OPA4344 used at feedback circuit of AC/DC converter

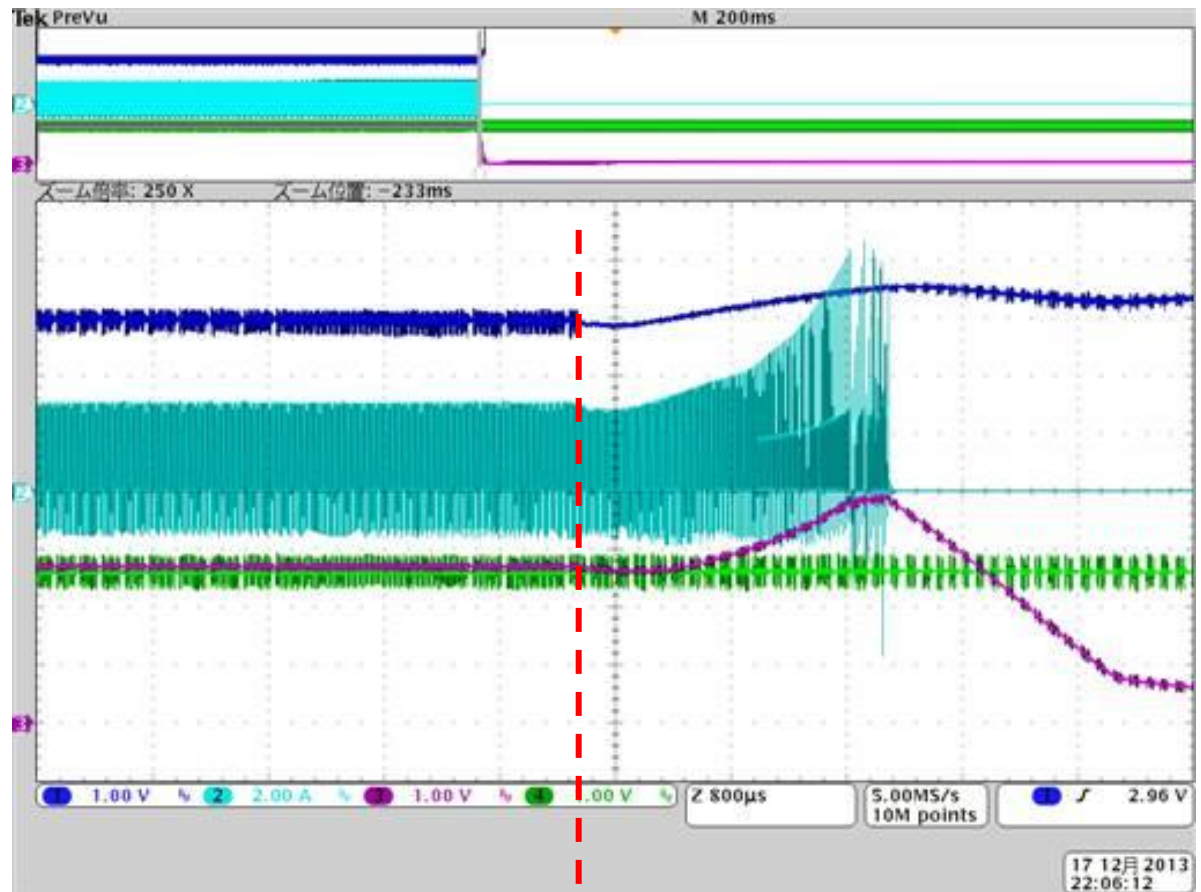
Ch1 : Output of OPA4344 (8pin)

Ch4 : -IN of OPA4344 (9pin)

Ch3 : +IN of OPA4344 (10pin)

Feedback control is operated normally before this point.

But it's uncontrolled suddenly.

We have not found any trigger of this behavior.

Can you give your comments for the reason why this behavior is happened and it's improved by adding RC filter on VCC?

This behavior is fixed by adding RC filter on VCC of OPA4344.
